FINAL DRAINAGE REPORT

**CIRCLE K at
HIGHWAY 24 & MERIDIAN ROAD**

September 2022

Project No. 21.1207.037

SHEET 1 OF 2
DR01
ISSUE DATE: SEPTEMBER 2022

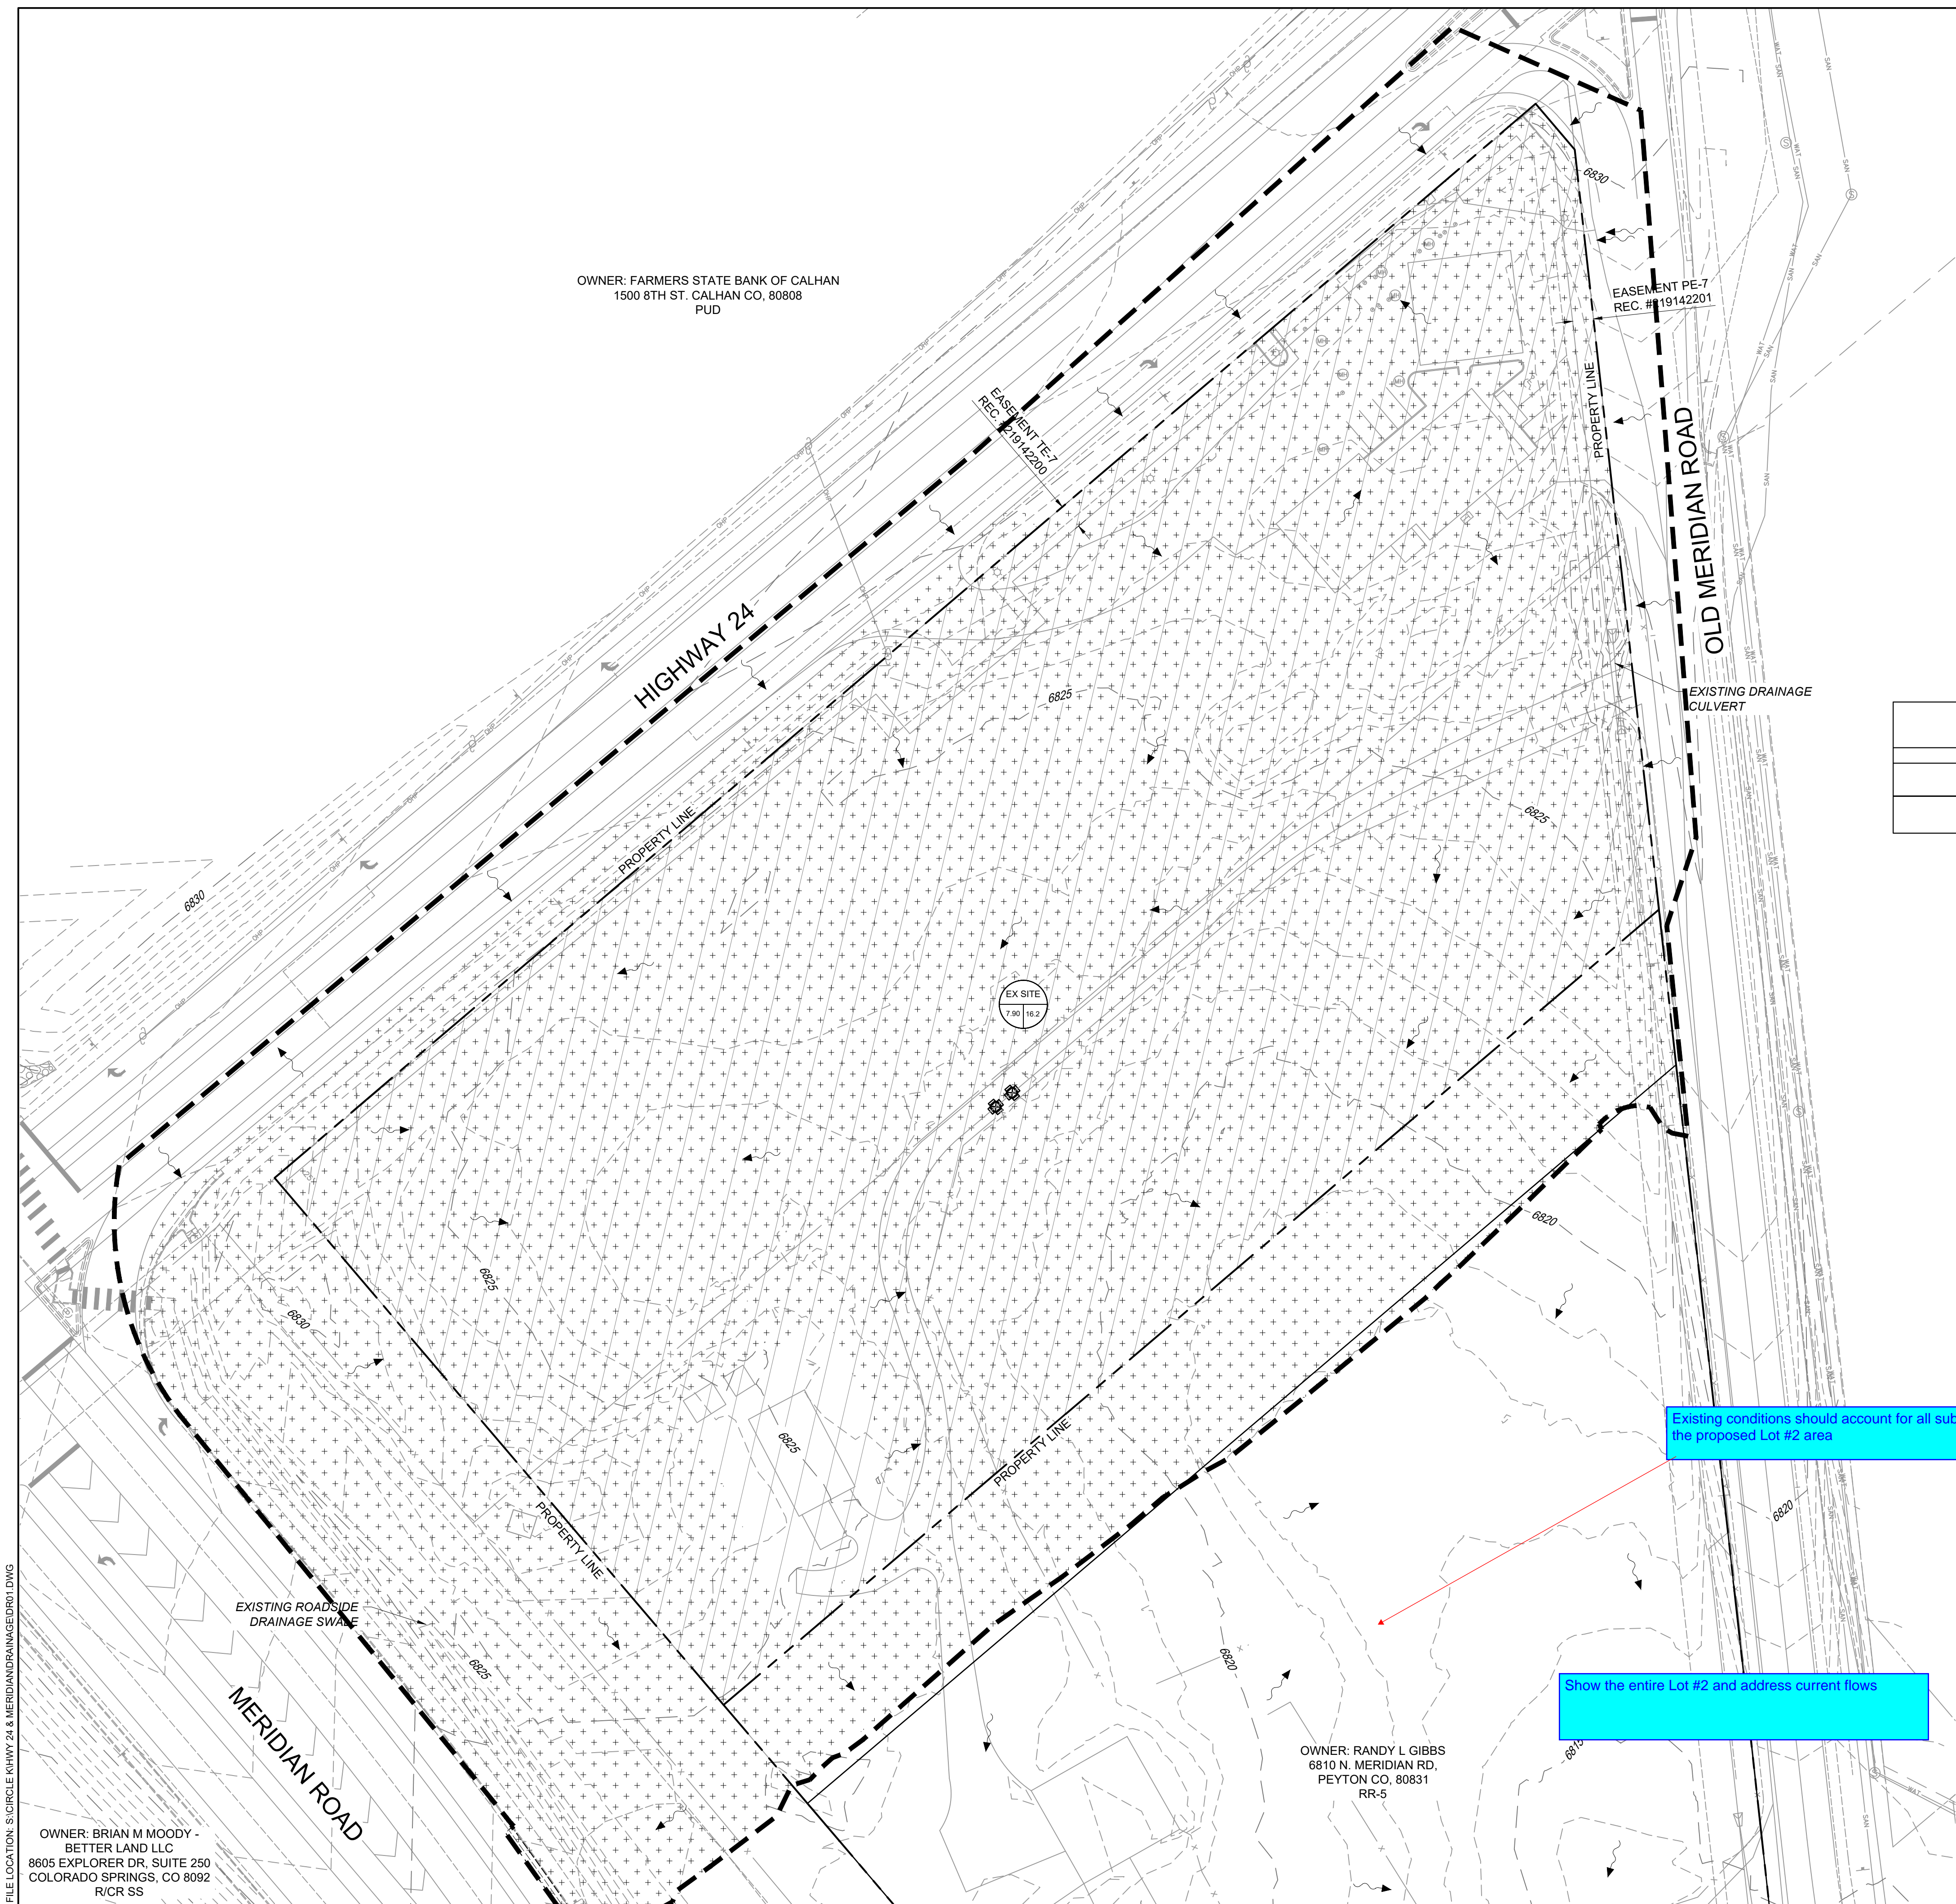
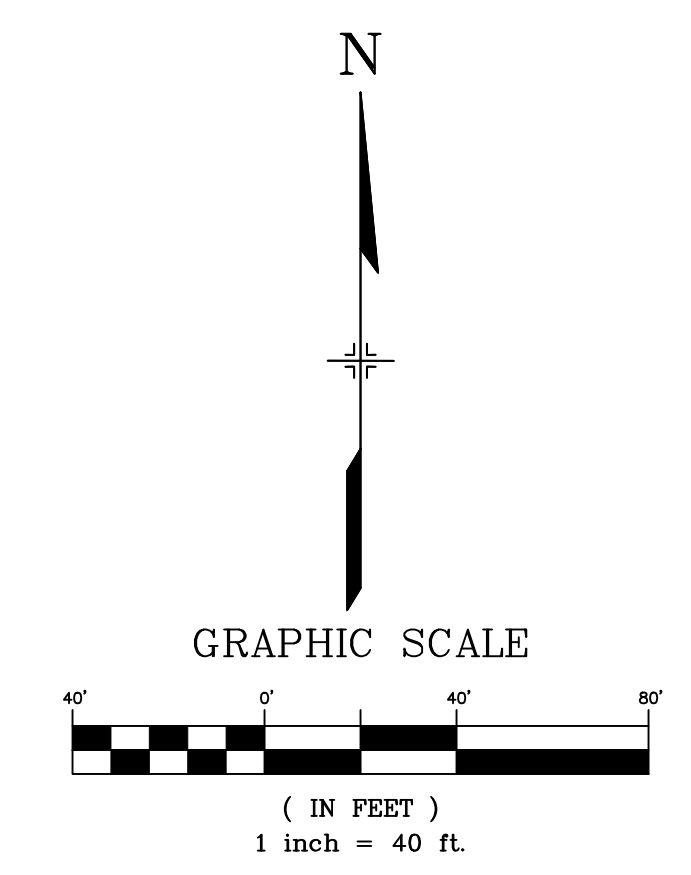
Existing conditions should account for all sub-basins in the proposed Lot #2 area

Show the entire Lot #2 and address current flows

SHEET 2 OF 2
DR02

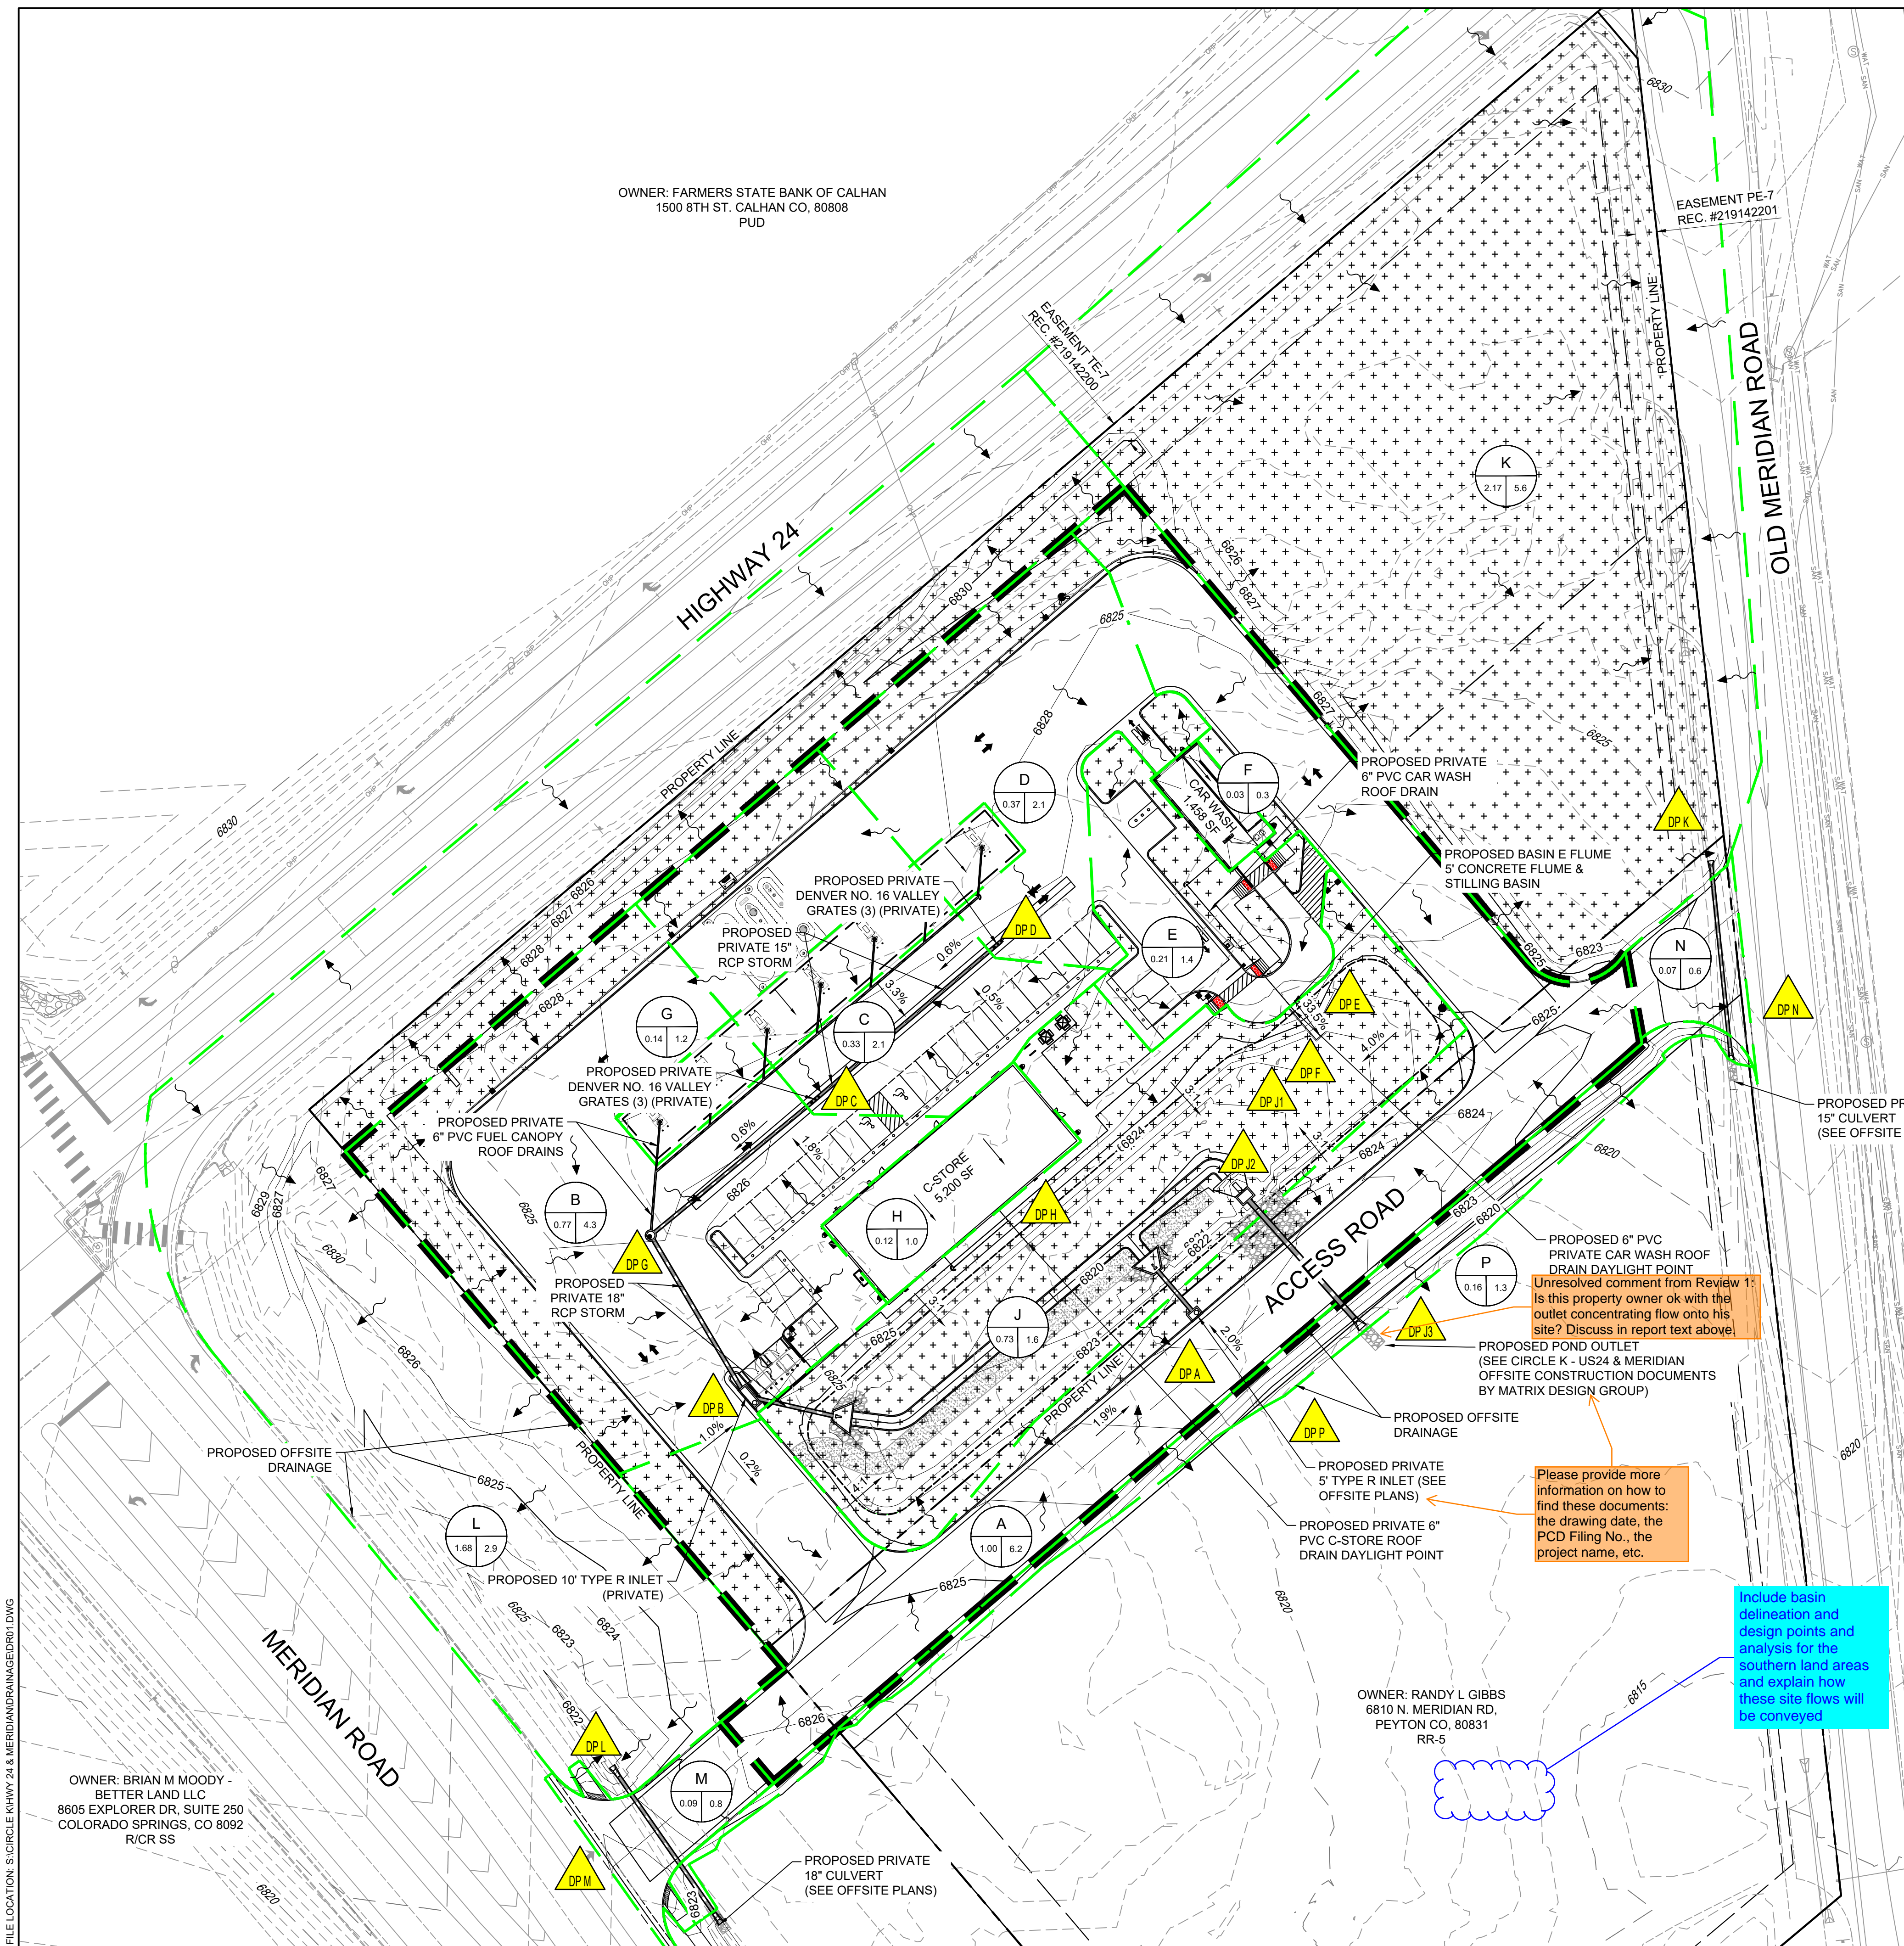
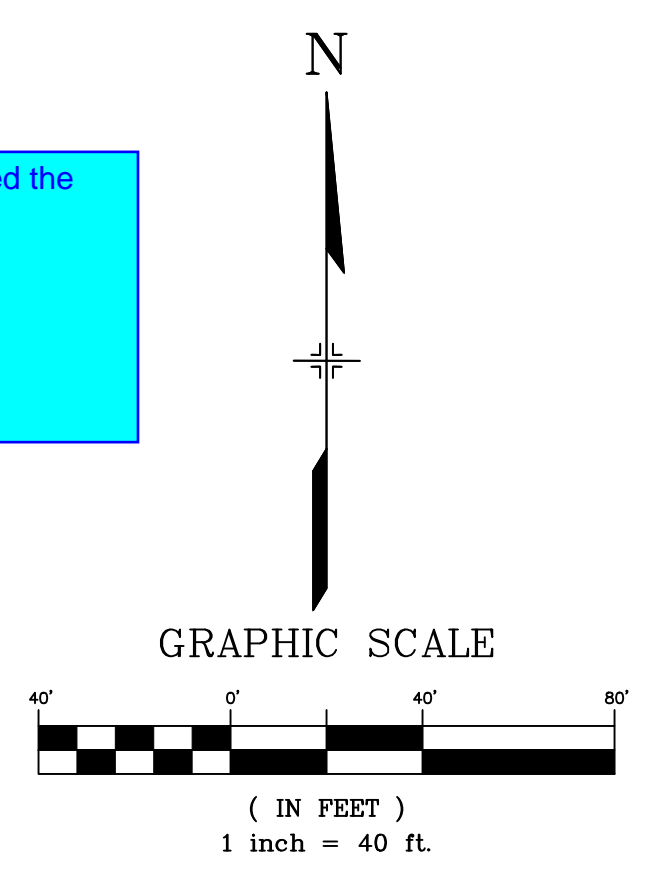
Unresolved comment from Review 1:
Is this property owner ok with the outlet concentrating flow onto his site? Discuss in report text above!

Please provide more information on how to find these documents: the drawing date, the PCD Filing No., the project name, etc.

Include basin delineation and design points and analysis for the southern land areas and explain how these site flows will be conveyed

Proposed conditions drainage map need to comprised the entire subdivision area and Lot #2
